ADDENDUM NO. 1 DATED 6/23/2016 ADDENDUM NO. _____ DATED _____
ADDENDUM NO. _____ DATED _____ ADDENDUM NO. _____ DATED _____

Number	Description
1	Revised Table of Contents; Delete NTB No. 1322; Revised NTB Nos. 5545, 6111, & 6119; Add NTB Nos. 6522, & 6523; Add SP 907-630-13; Delete SP 907-630-15, & 907-721-4; Revised Bid Items; Revised or Added Plan Sheet Nos. 2, 6, 8-9, 18-20, 22, 24-26, 37, 40, 42, 44, 50, 195, 197, 199, 205, 1001-1015, 3022-3024, 9045-9050 for Projects 102556306 & 307; Revised or Added Plan Sheet Nos. 2, & 11 for Project 102556318; Amendment EBS Download Required.

STP-0029-02(018) / 102556306000, STP-0029-02(018) / 102556307000 & STP-0029-03(015) / 102556318000
Desoto & Marshall County(ies)

PROJECT: STP-0029-02(018) / 102556306 - Desoto
STP-0029-02(018) / 102556307 - Marshall
STP-0029-03(015) / 102556318 - Marshall

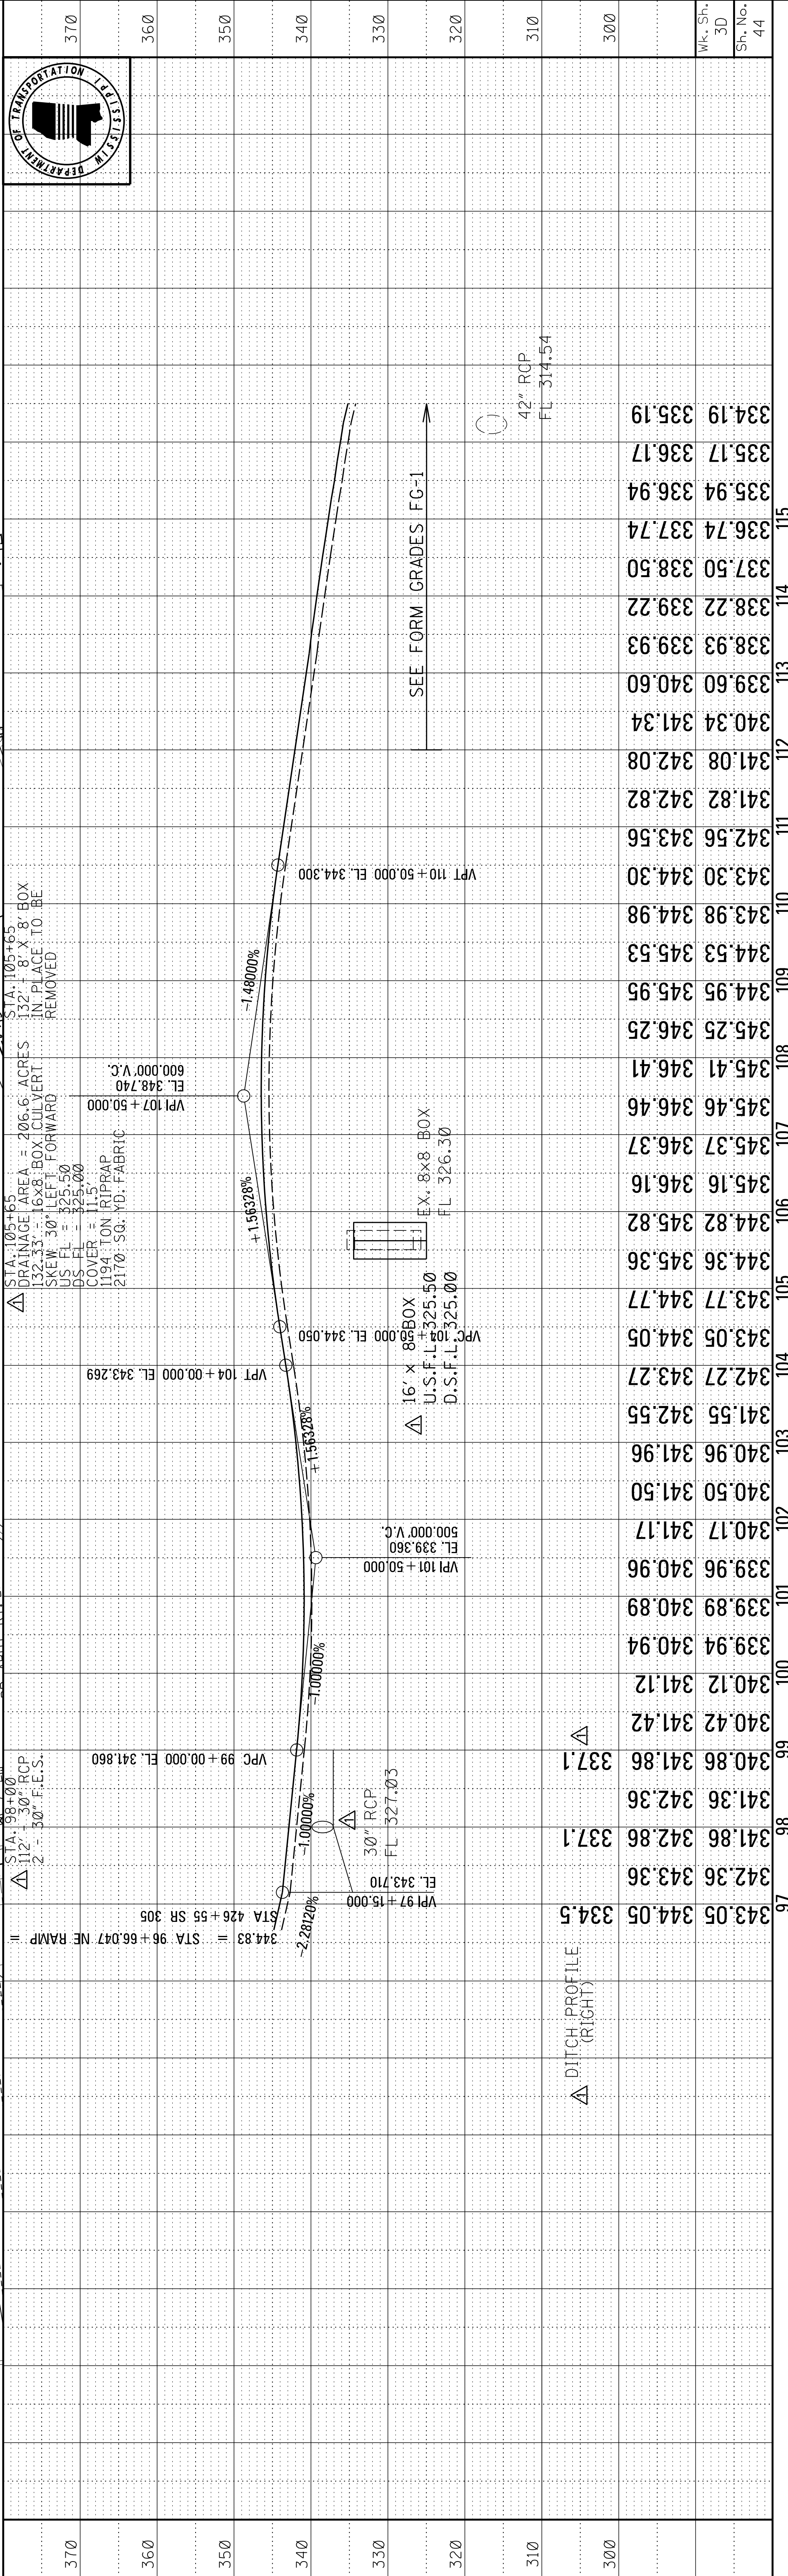
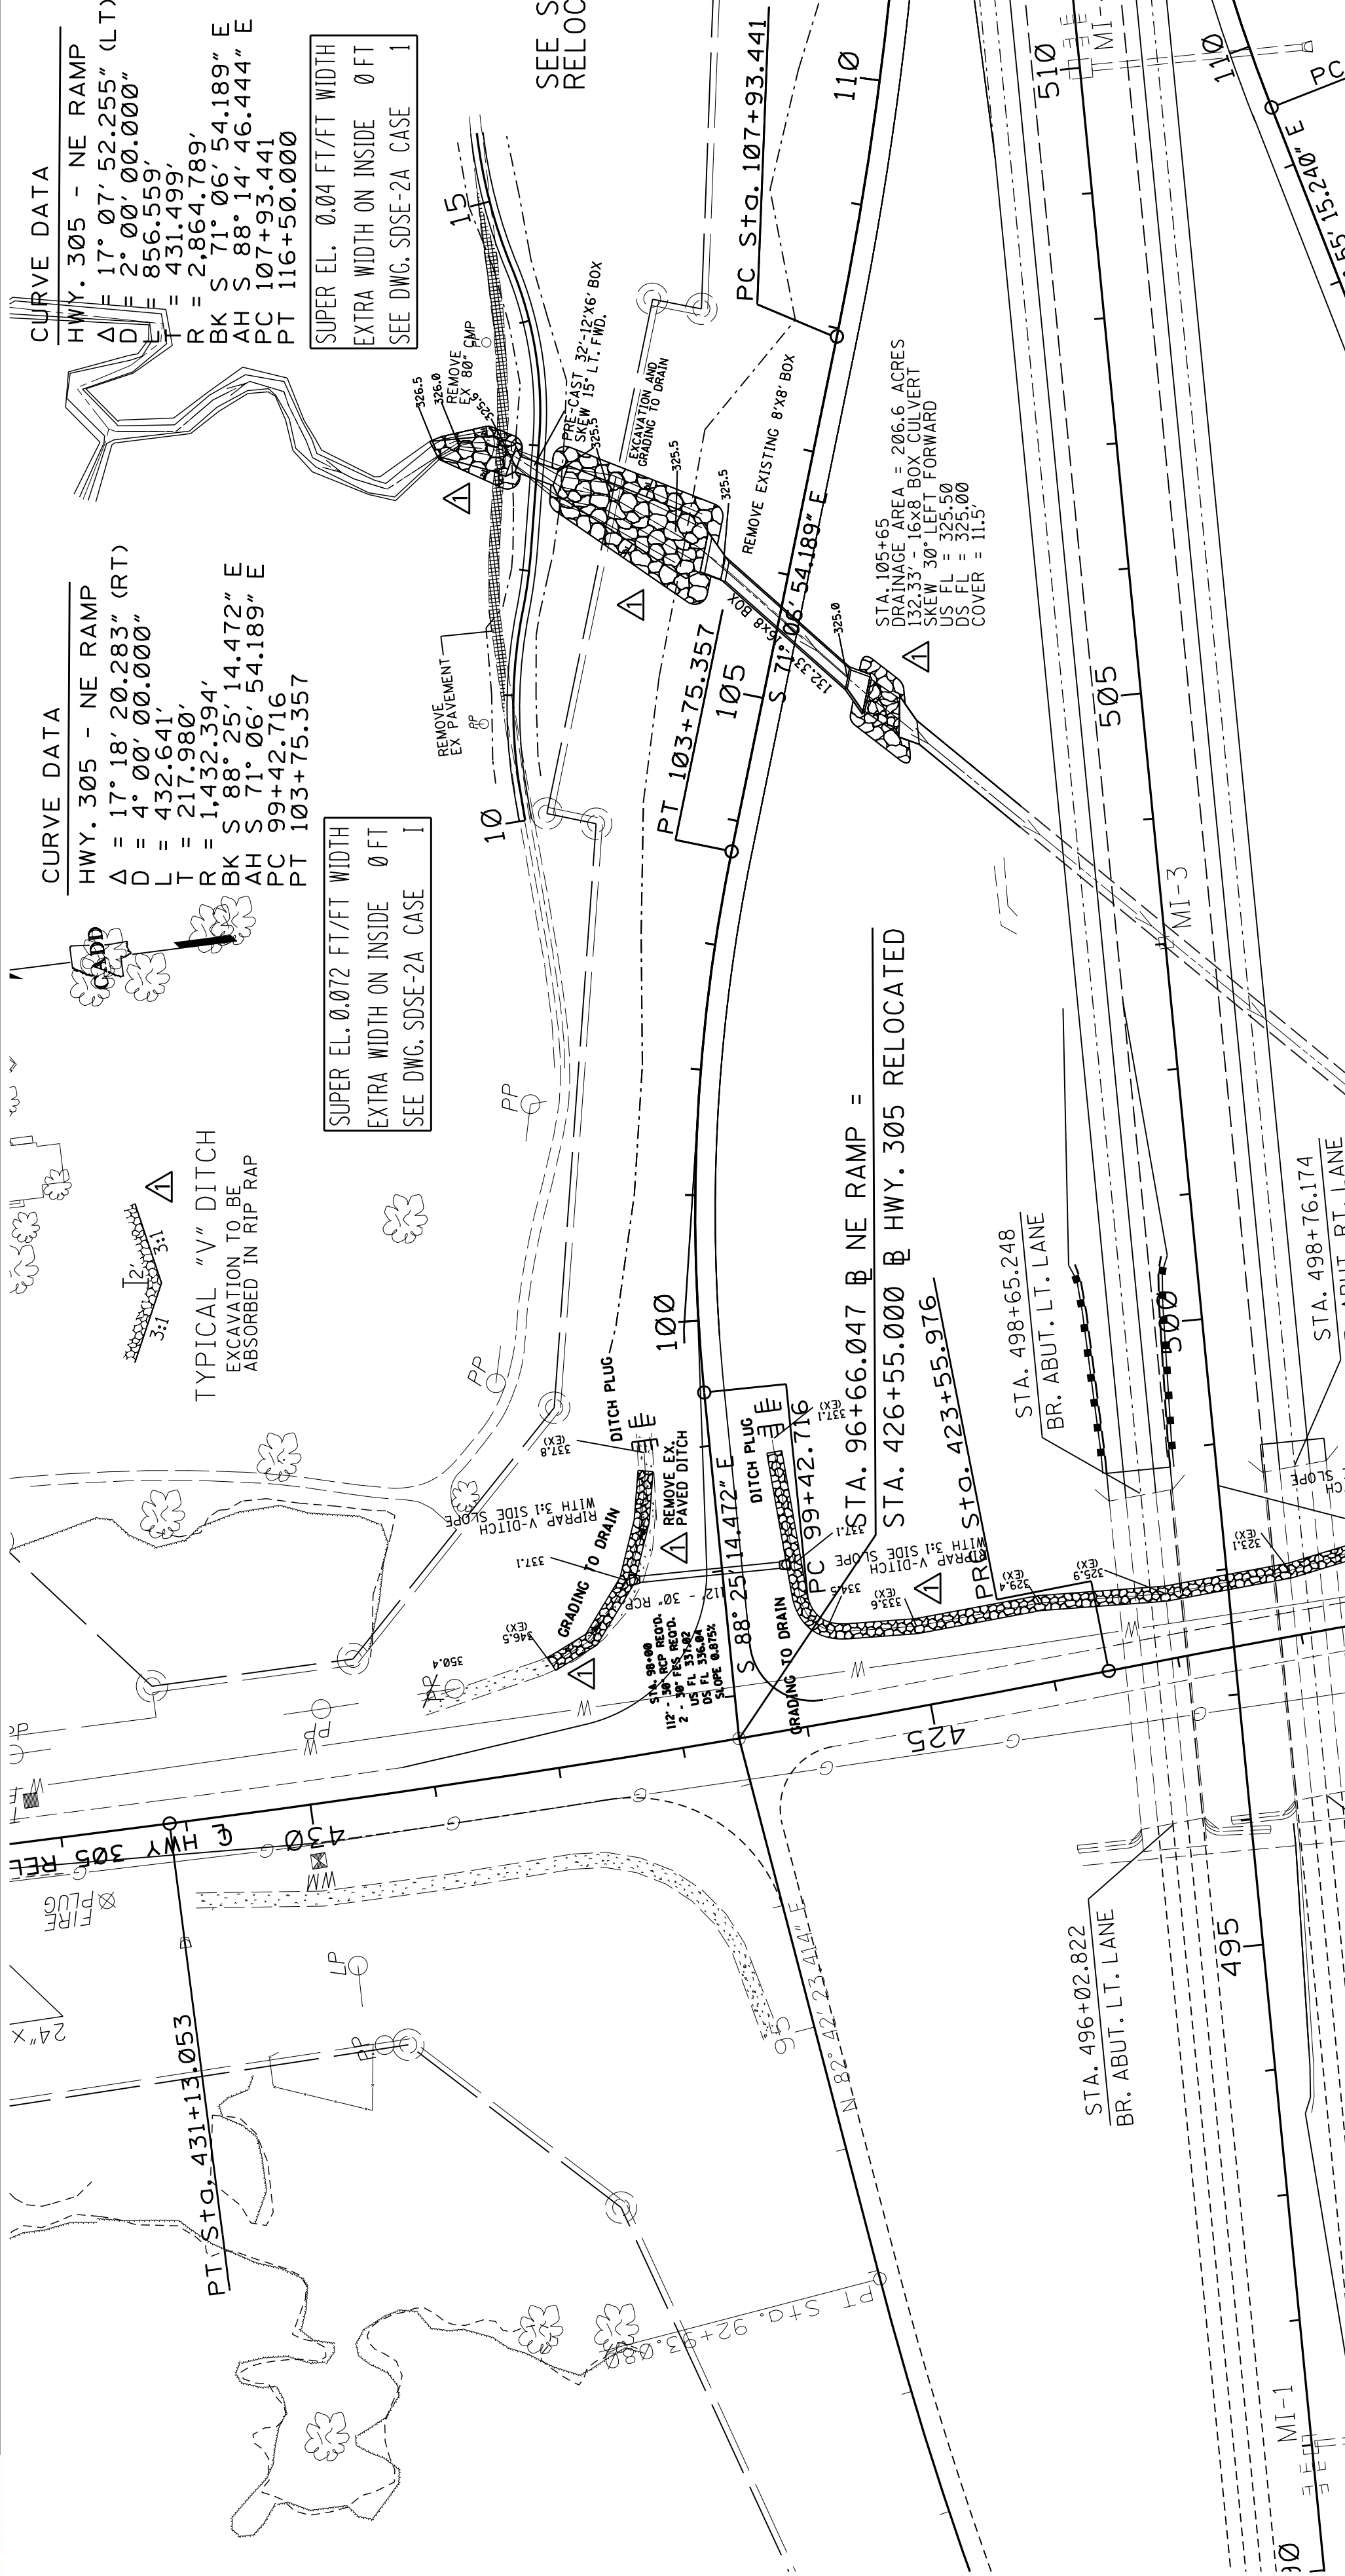
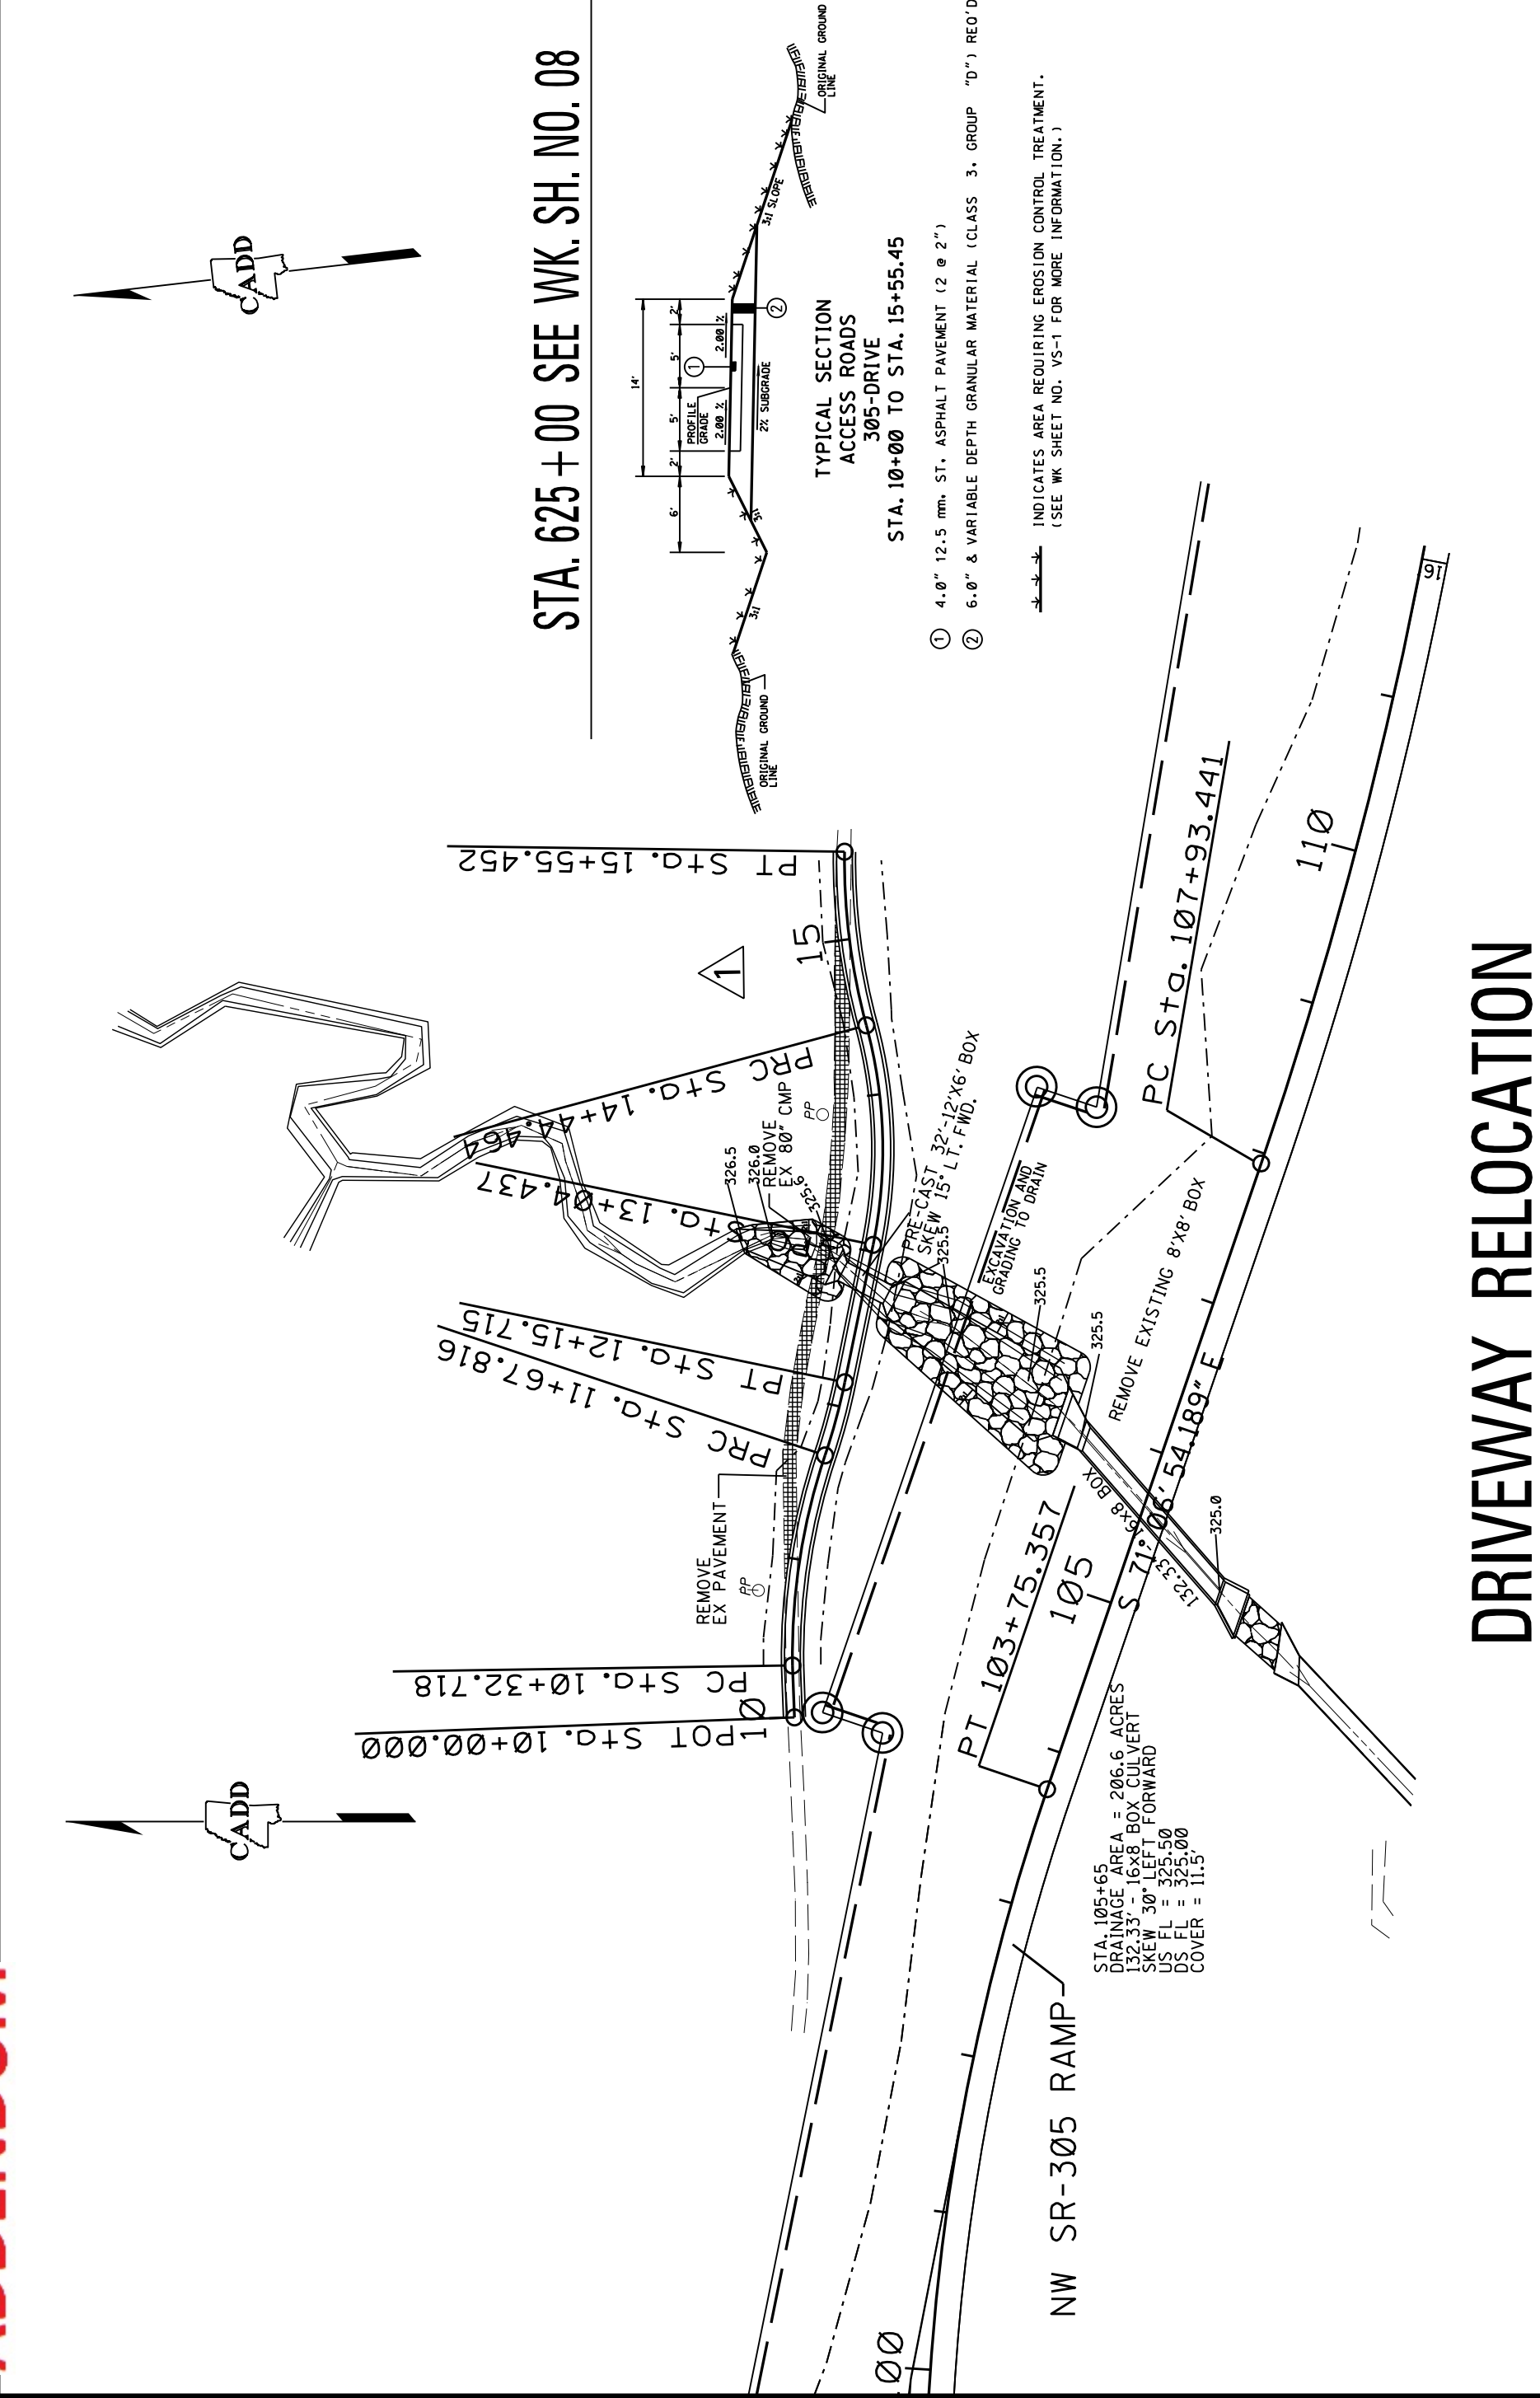
SEE SHEET WK-9 FOR
RELOCATION OF DRIVEWAY

REPLACED BOX CULVERT
ADDED ACCESS ROAD
ADDED RIPRAP DITCH
